# Rezoning Transportation Analysis

Petition Number: 2019-008

General Location Identifier: 08109921

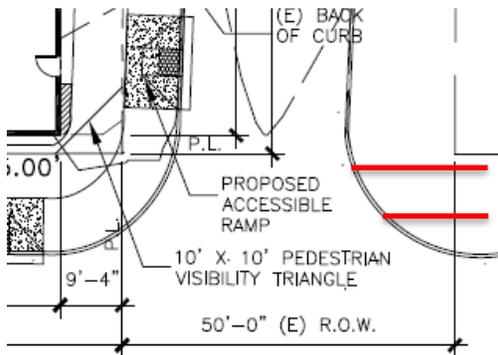
5. The petitioner should rebuild the receiving ramps at the corner of Seigel Avenue and East 15<sup>th</sup> Street to meet City of Charlotte and PROWAG standards.
